BAW-10122A

NORMAL OPERATING CONTROLS

SUBJECT: EVALUATION OF BAW-10122

Subject: Response to Questions on Topical Report BAW-10122

Figure 4-5. Linear Heat Rate Vs APSR Position

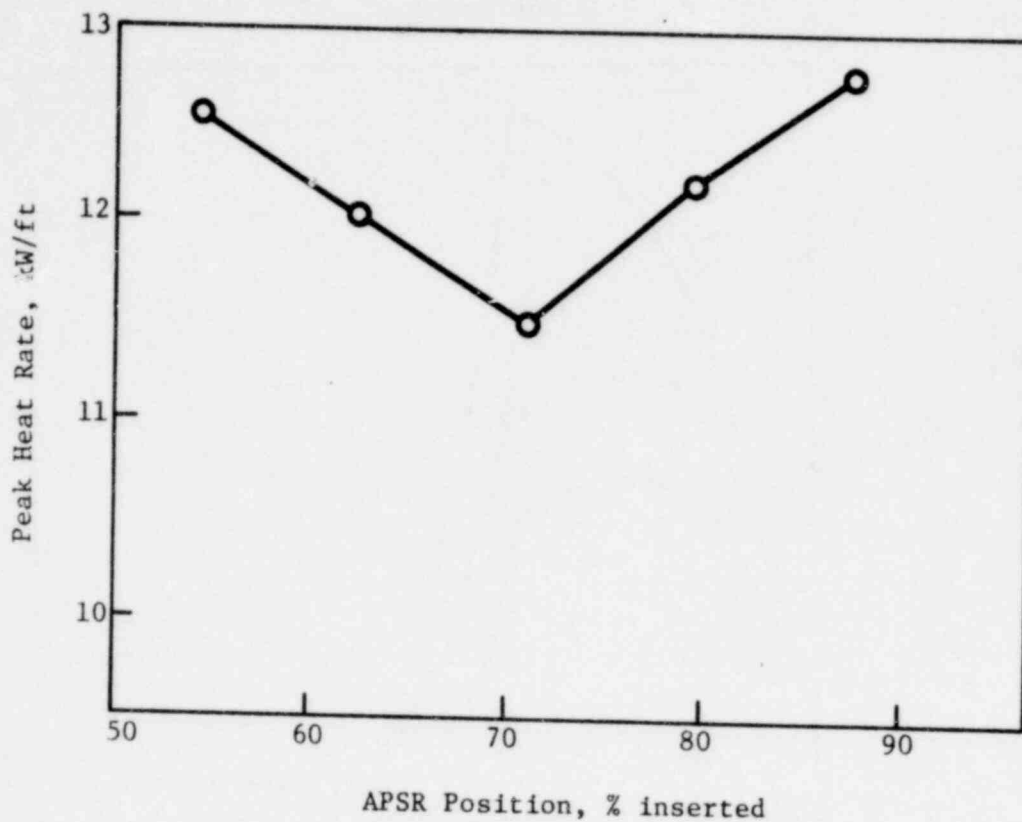
QUESTION

232.2:

(Fig. 4-5)

Presumably the shape of this curve depends on the location of the other rods in the core and on core burnup. How are these effects handled in establishing operating limits?

Figure 4-5 was included for illustration only and represents the peaking response for beginning of cycle conditions with a nominal (12.5% insertion) position for the Bank 7 control rods. As described in Section 4.1.2.1, when operating limits are established, APSR scans are run for various control rod (Bank 7) insertions at several, selected core burnups. Control rod and offset limits are developed for each burnup, and the most restrictive limits are specified for the burnup interval chosen (either all or part of a cycle, as discussed in Section 4.1.1.5.).

Figure 4-9. Babcock-205 LOCA Margins, 102% Full Power

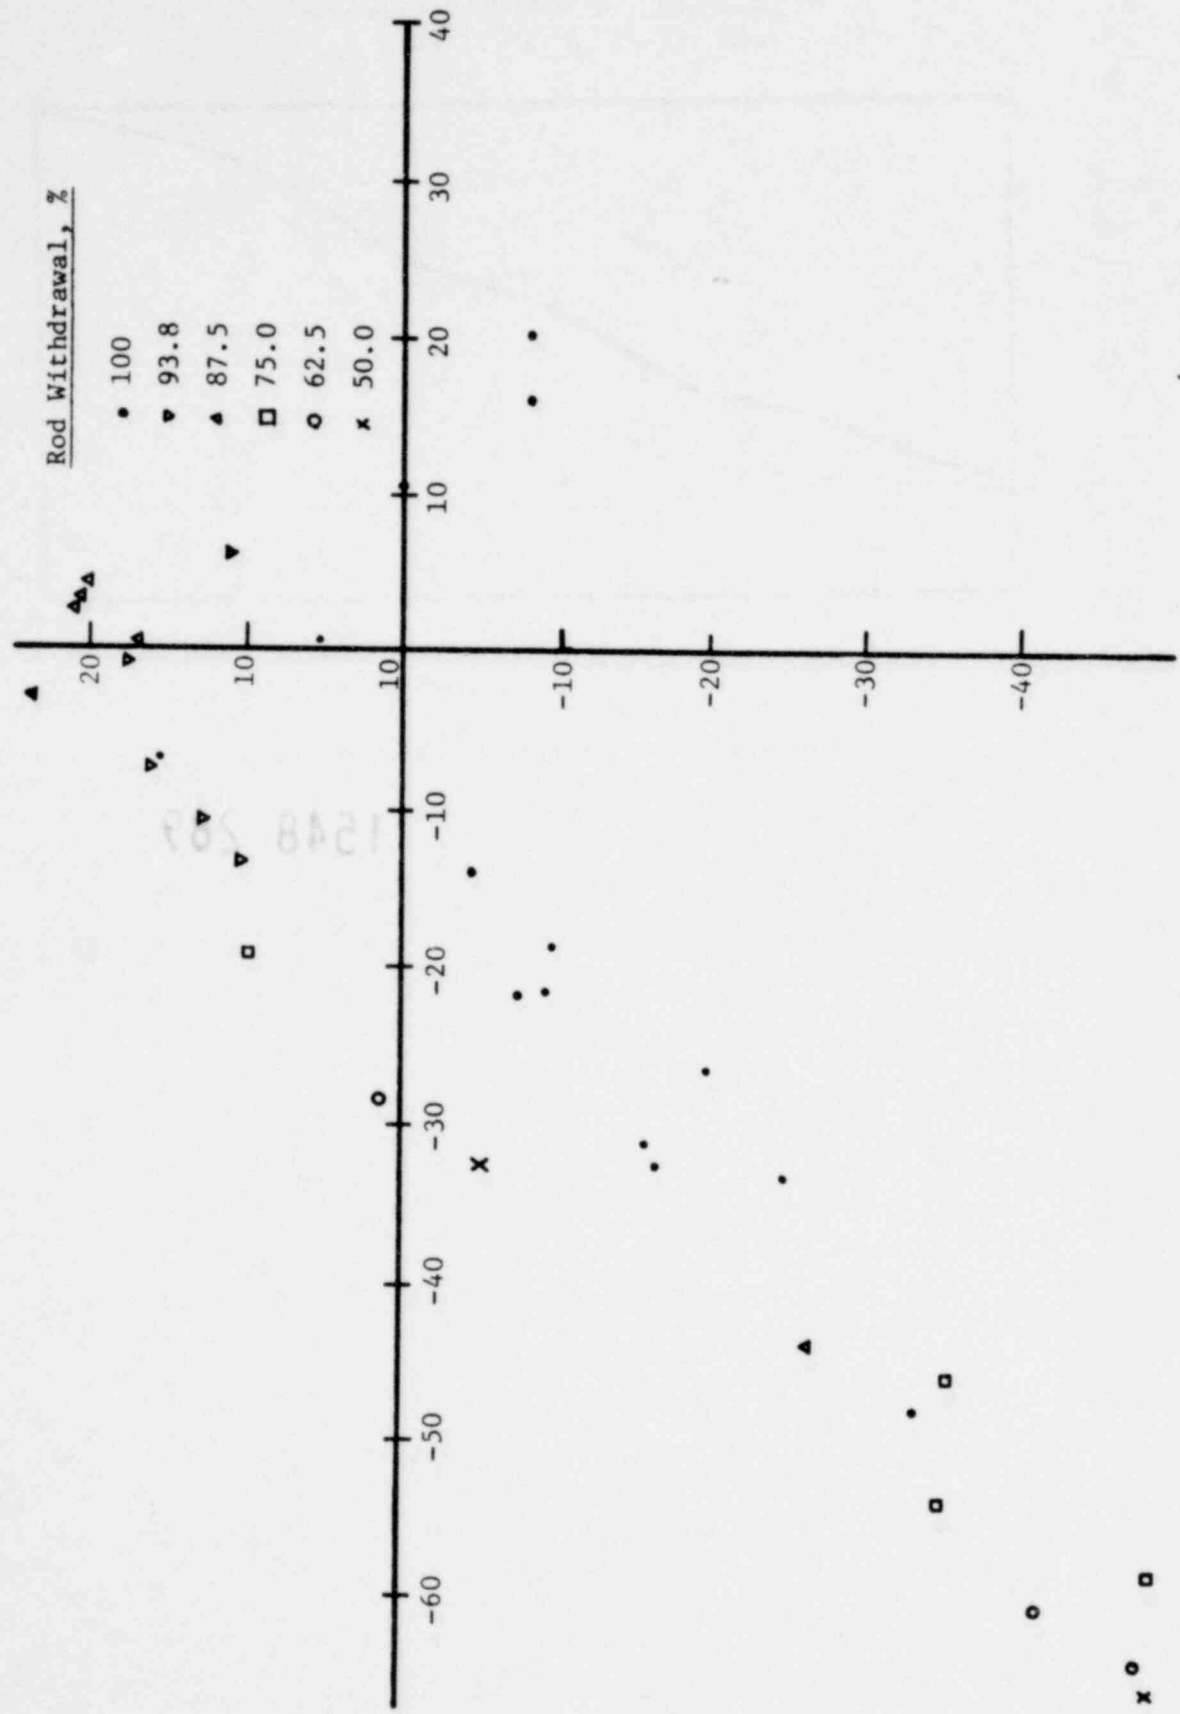
## QUESTION

232.5

(Fig. 4-9)

APSR positions are not indicated on this figure. Is the inference to be made that the most adverse APSR position is to be associated with each point? Or, are all points for the same APSR position?

Each point on the Figure represents a single calculation for a fixed APSR and Bank 7 position. The different Bank 7 positions are represented by different symbols. Each point shown with a given symbol represents a different APSR position. In general, one can follow an APSR scan by connecting the points with identical symbols. This is most easily observed by considering three points for 100% withdrawal of Bank 7. Starting with the point at ~11% positive offset and ~0% margin, this represents an APSR position of 12.5% withdrawn. Moving to the point at ~1% positive offset and ~5% positive margin, this represents an APSR position of 25% withdrawn. Similarly, the point at ~14% negative offset and ~5% negative margin is for an APSR position of 37.5% withdrawn. Other points for 100% Bank 7 withdrawal are either continuations of this APSR scan for equilibrium xenon, or are scans at other xenon conditions, as discussed in paragraph two of Section 4.1.2.3. Only a representative sample of end of cycle cases are plotted on Figure 4-9, in order to show different symbols for the different Bank 7 positions and the behavior of the offset/minimum margin points for various APSR positions and xenon conditions.
